# Residential Development Plans

Assessor's Parcel 220-87-2  
 74 EMERY STREET  
 &  
 Assessor's Parcel 220-87-3  
 64 EMERY STREET  
 Portsmouth, New Hampshire

**Re: Application for Site Plan Review - Planning Board Approval  
Assessor's Map 220, Lots 87-2 and 87-3  
74 and 64 Emery Street  
Altus Project P4916**

SHEET NUMBER:  
**C - 1**

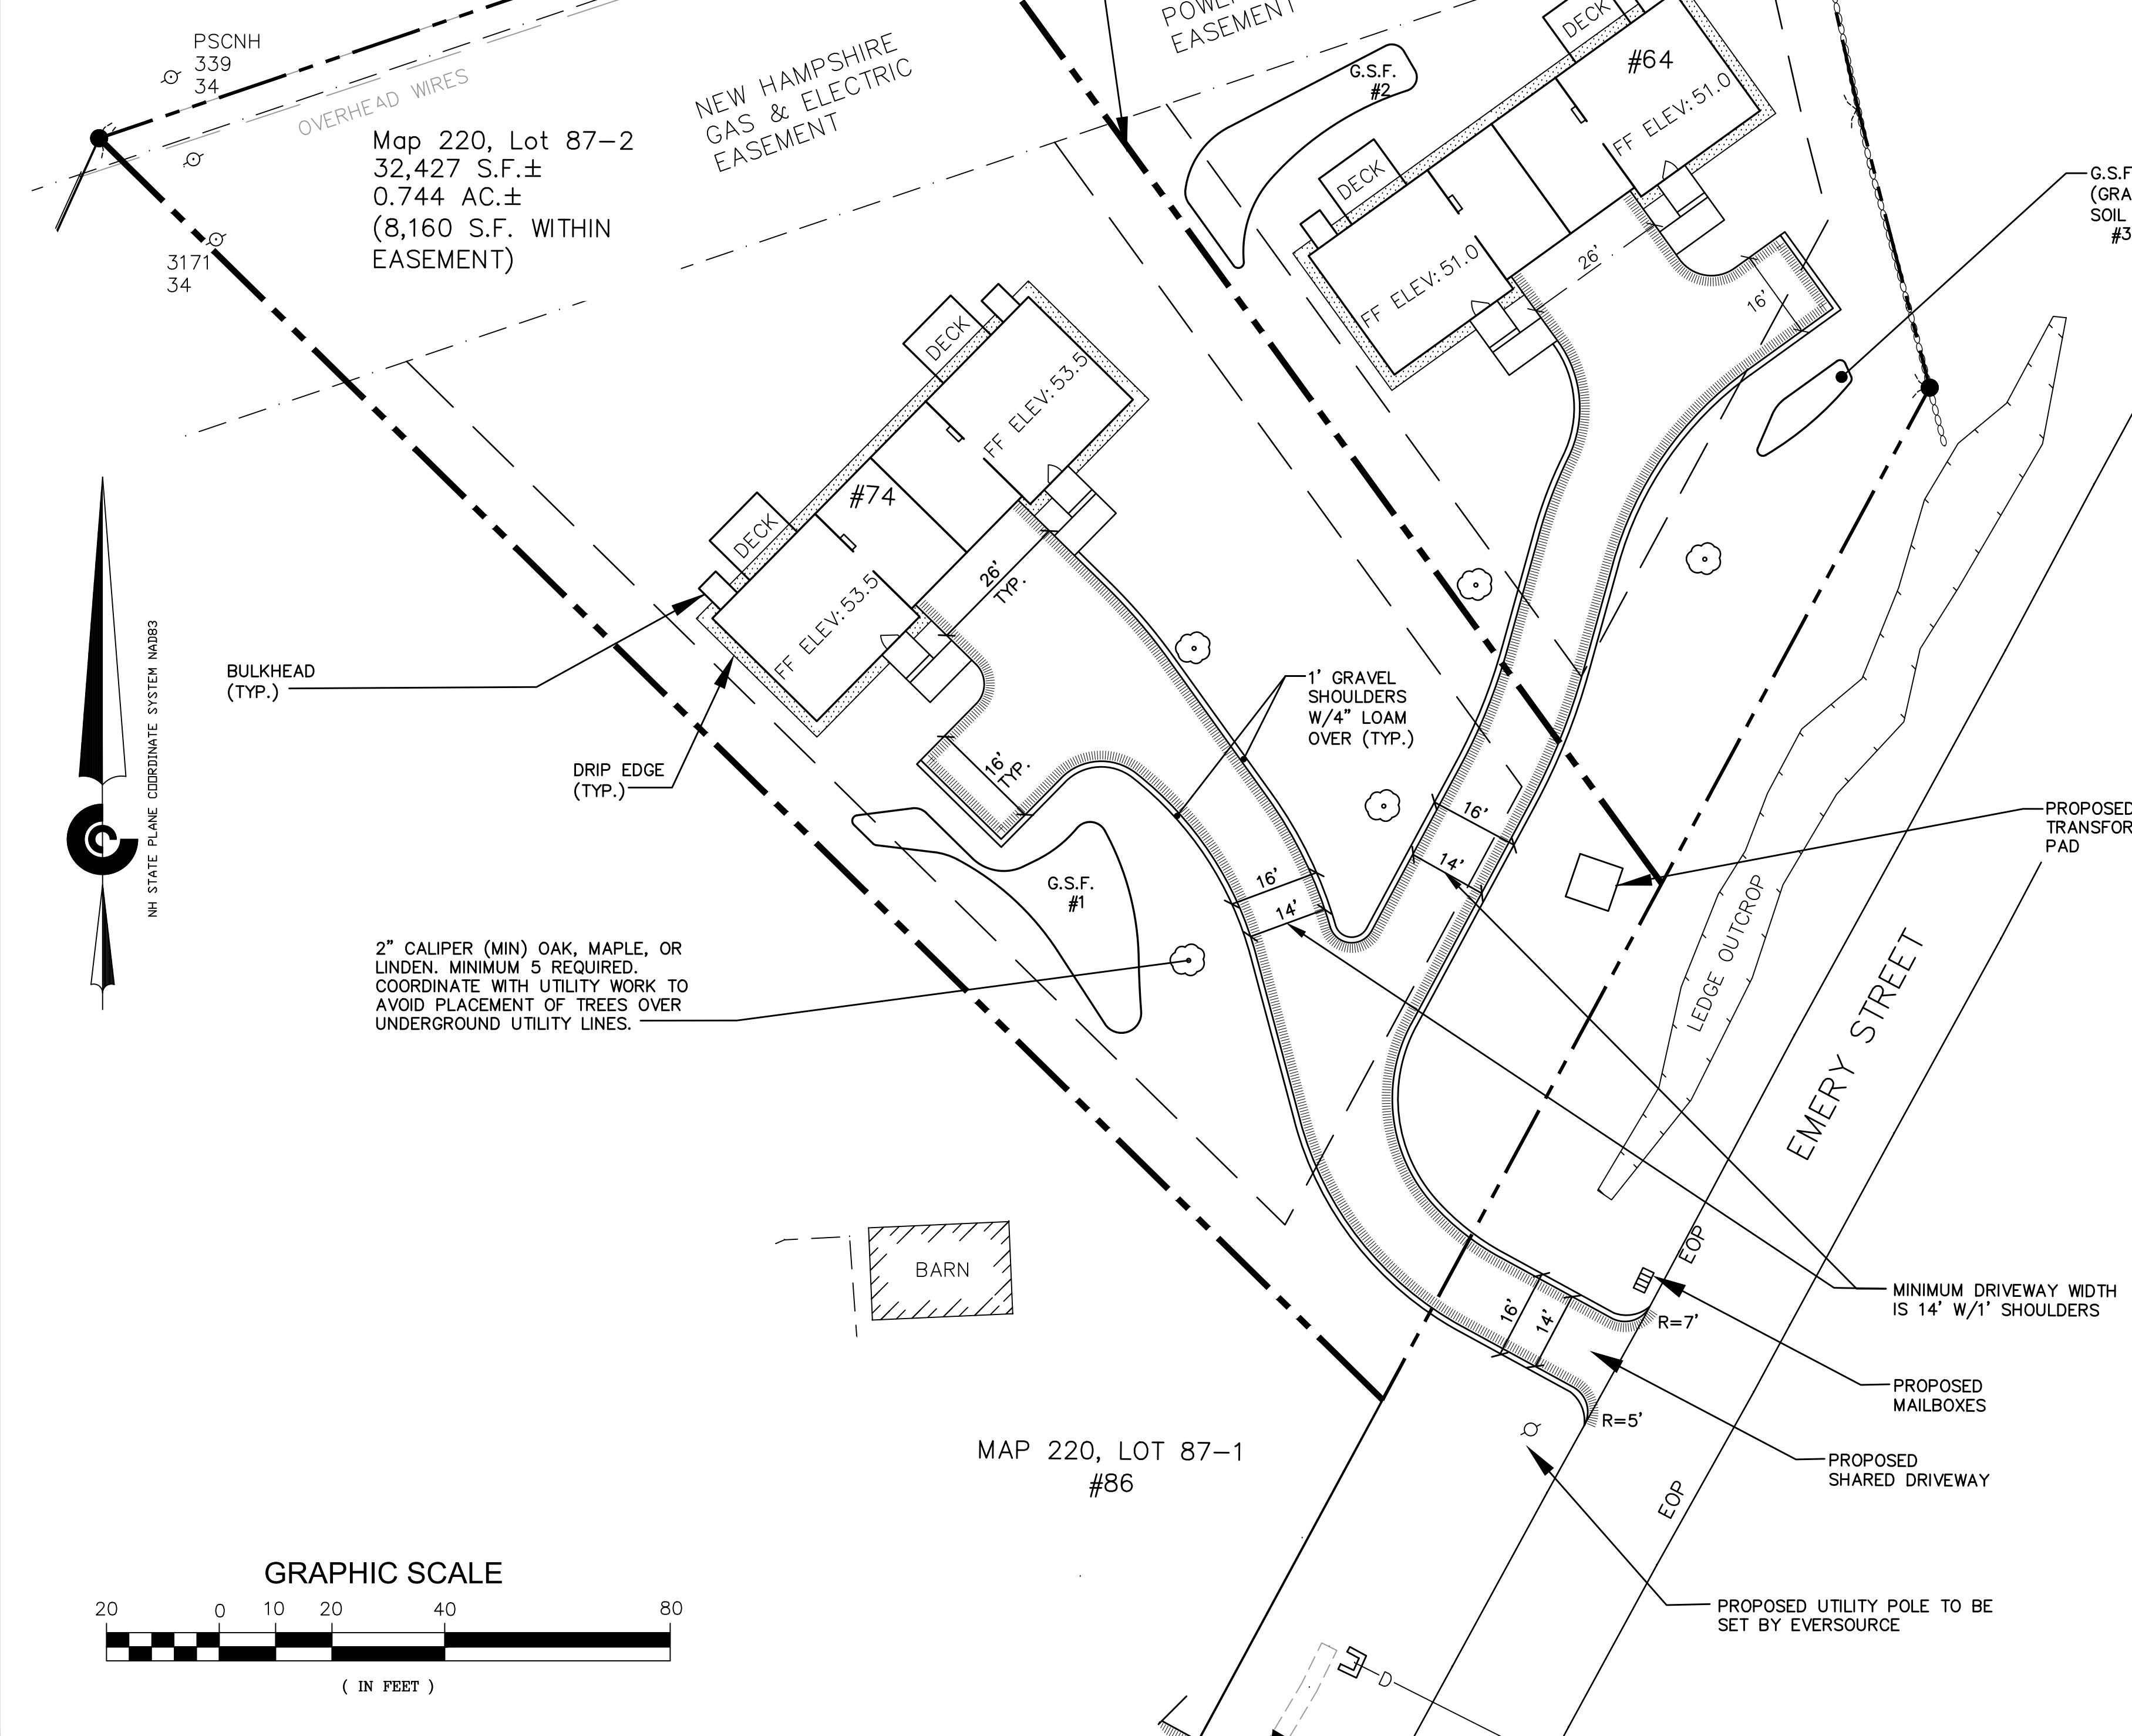
1. *Applicant shall show outline of proposed stormwater areas on the site plan so that it is clear to future homeowners.*

*Response: The stormwater areas have been added to the site plan, sheet C-1.*

SHEET NUMBER:  
**C - 2**

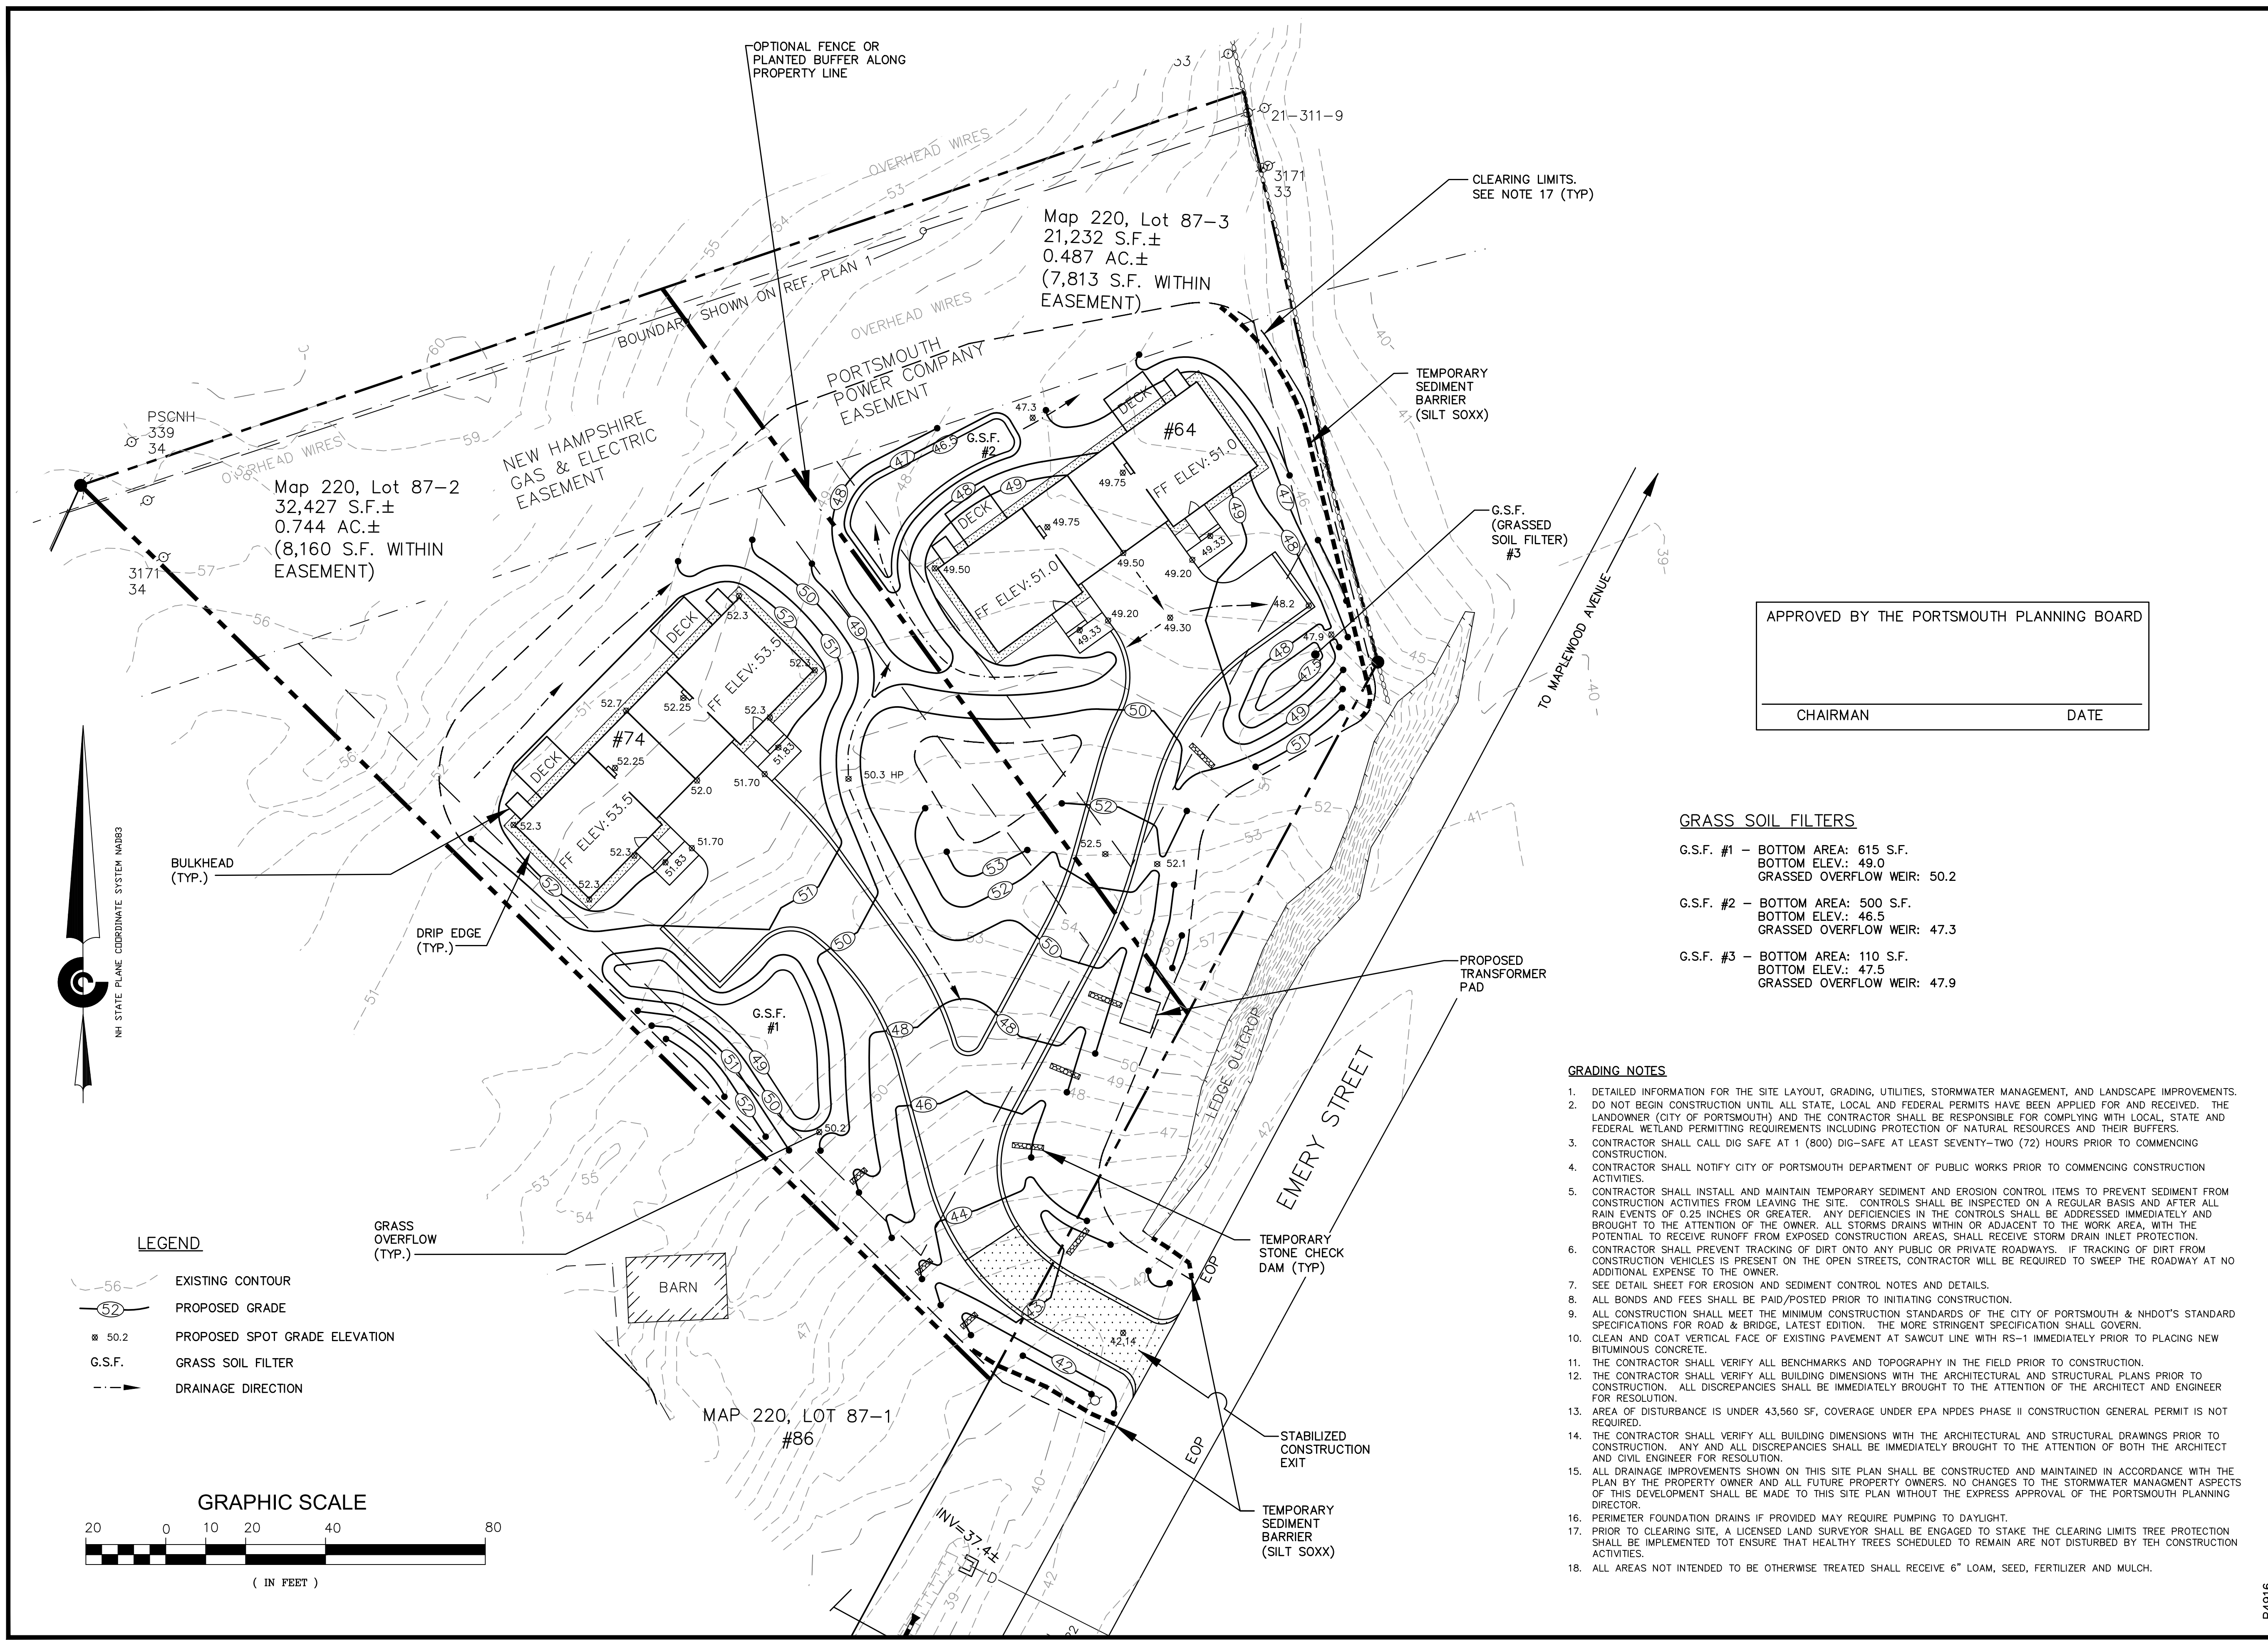
9. *Drainage and grading shall be updated and clarified to address TAC comments and approved by Planning and DPW staff prior to Planning Board review.*

*Response: The grading plan has been updated and is submitted for final approval.*
